Ref: P180403

**RE: EdgeConneX Ireland Ltd., Retention & Completion of Amendments,
Ballymaikaily, East of the Newcastle Road, (R120), Lucan, Co. Dublin
Planning Reg. Ref. No. SD22A/0009**

Further to the Additional Information request pertaining to Item 2, in respect of the above development, as received from the Local Authority, dated 11th March 2022. we would respond as follows:-

DRAWING STATUS INFORMATION			
SCALE	DATE	DRAWN	CHKD
1:2000	25.09.18	KR	SO'R
DRG NO	REV	SIZE	
210	A	A3

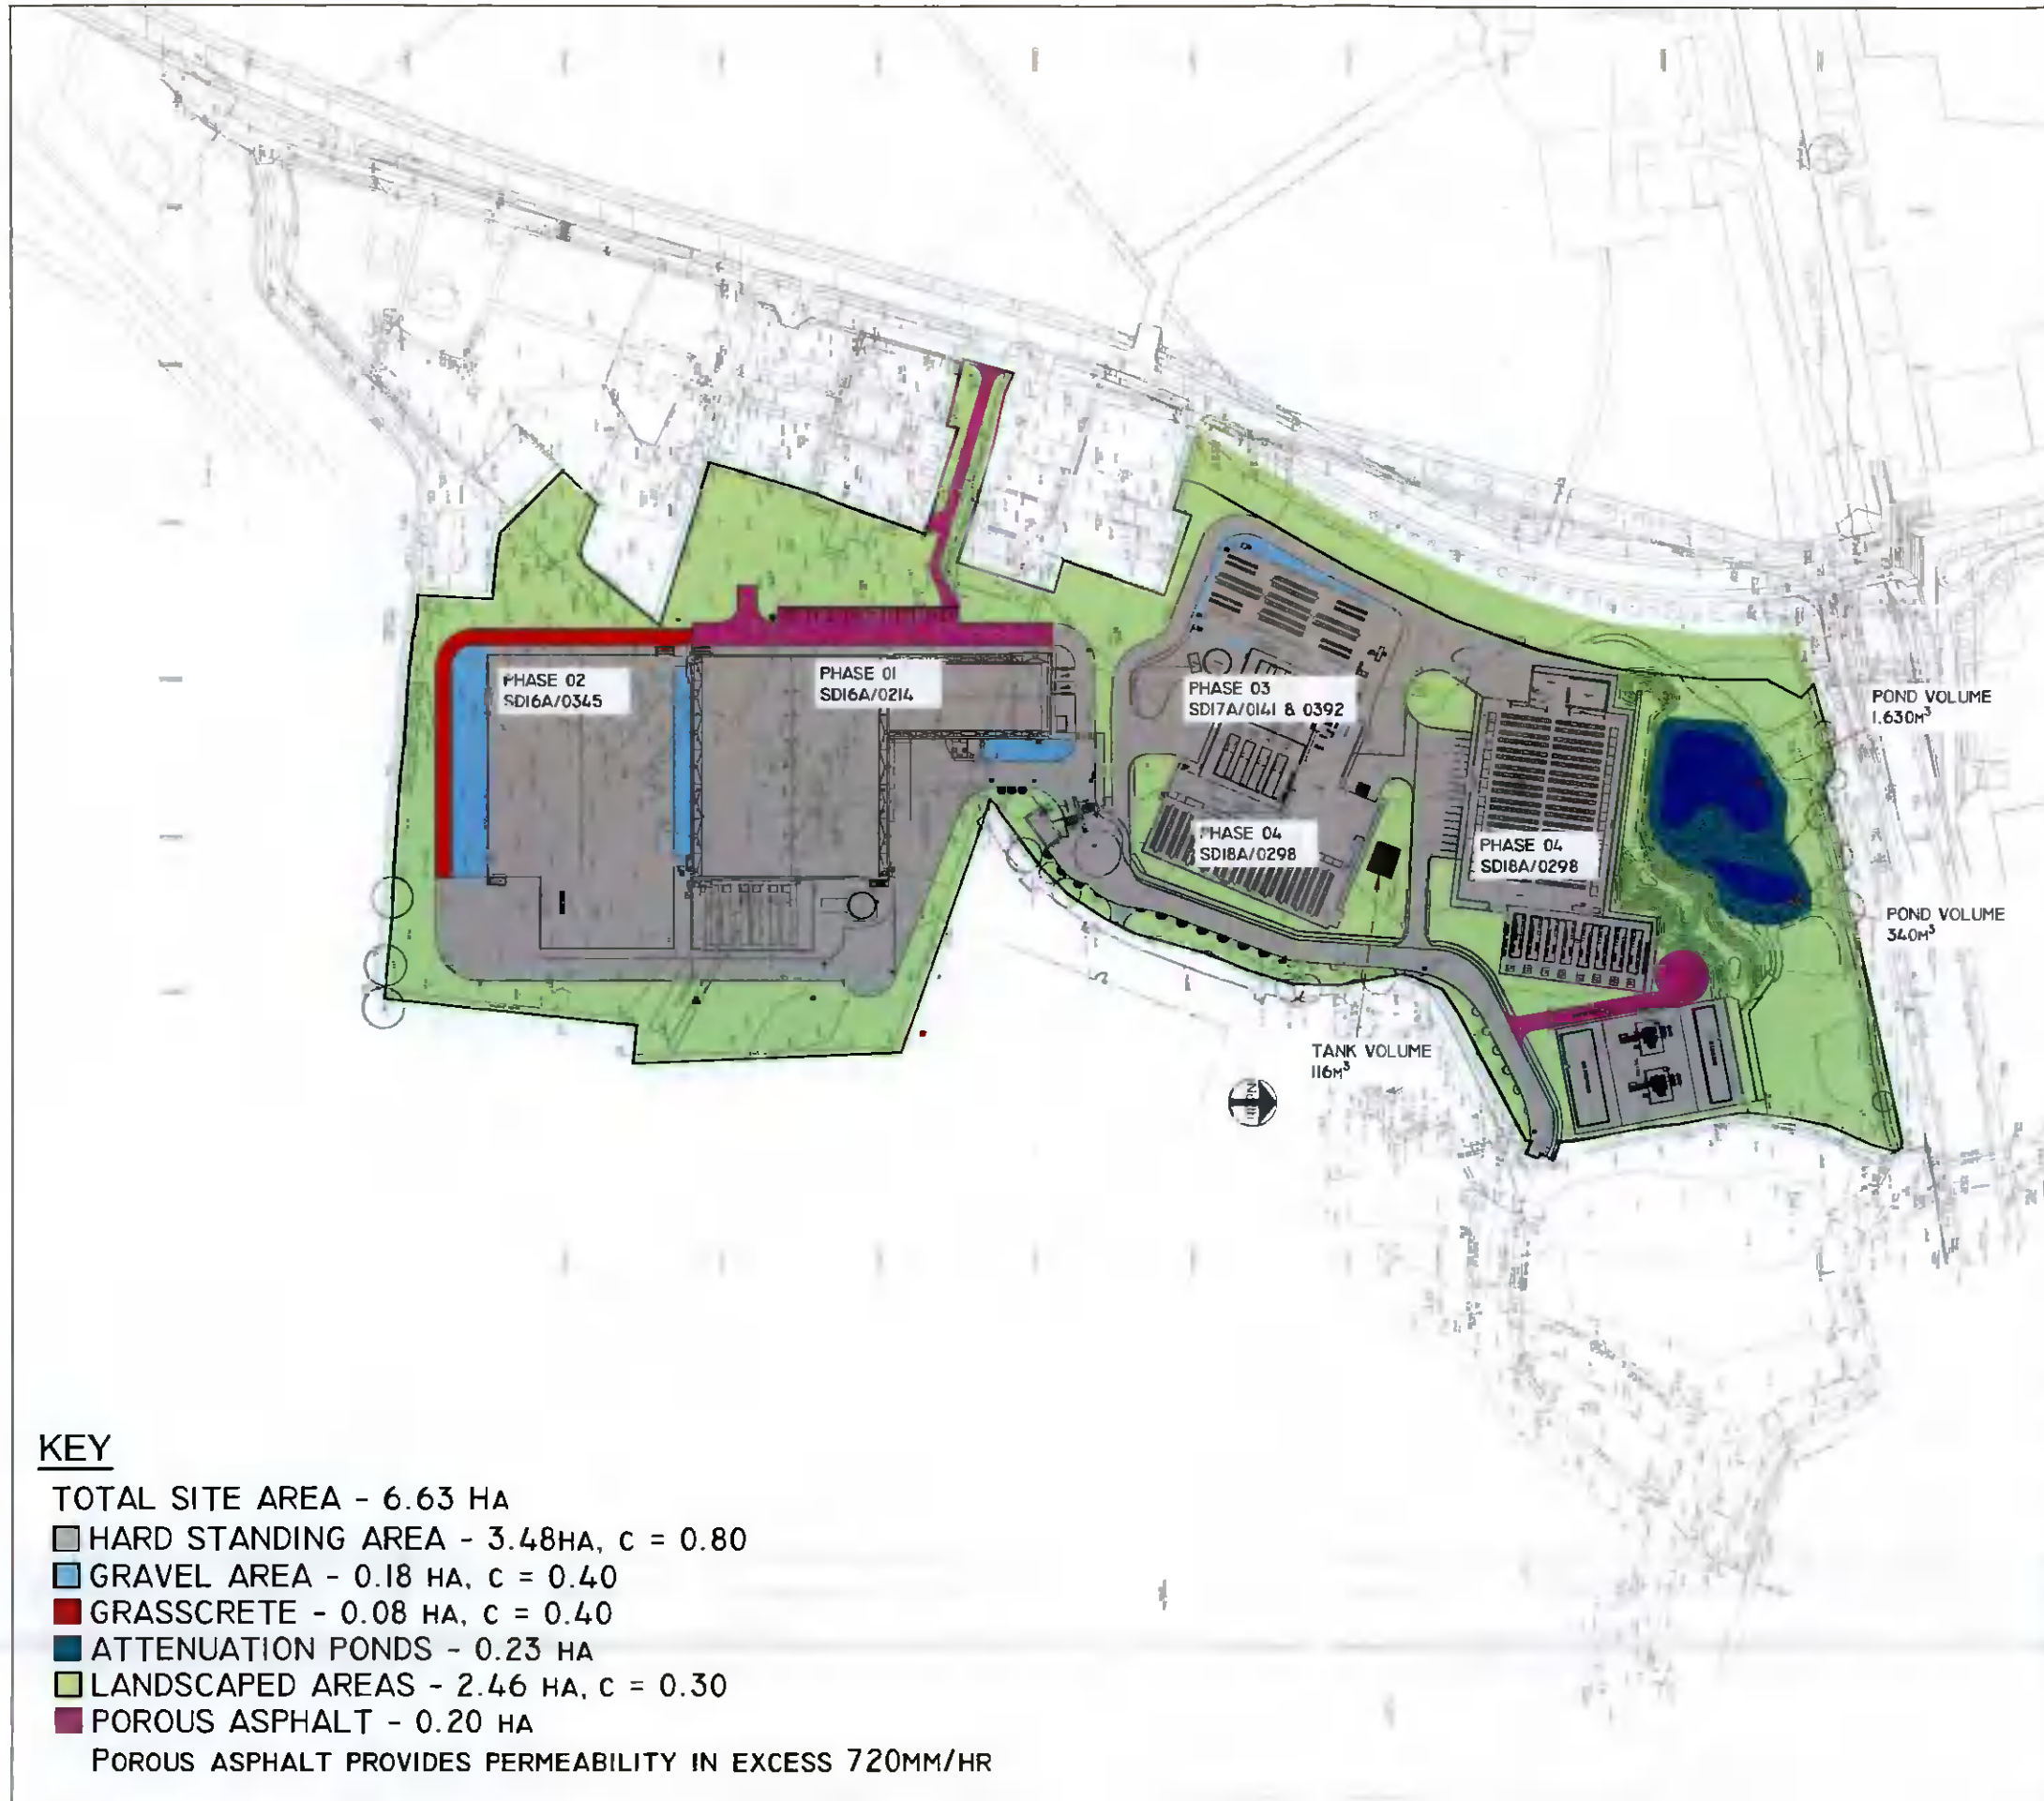
2. It is unclear what surface areas of site are being affected by proposed development. There are no drainage drawings submitted showing the surface water layout of existing and proposed development. The applicant is requested to:

(1) Submit a report to clearly show surface water attenuation calculations, surface areas in m², runoff coefficients of existing and proposed development including areas to be retained.

(2) Show in a report and drawing what surface water attenuation is proposed and required in m³ for existing and proposed development.

(3) Submit a drawing showing the surface water layout and attenuation for existing and proposed development.

Refer to Dwg. No. P180403-210 Rev. A, which was submitted as part of the Compliance pack, in order to indicate the volume of surface water attenuation provided, for the entire EdgeConneX campus. The submitted compliance was signed off by Water Services, as received on the 4th April 2019 – refer Appendix A.

In addition to the above, this retention application contains circa 1,017m² of additional hardstanding, comprising of additional sections of concrete footpath, which are not accounted for in the original scheme. Based on a Co-efficient of 1.00, the additional attenuation required in order to provide for the additional hardstanding areas equates to circa 36m³ – refer Dwg. No. P180403-299 & Appendix B.
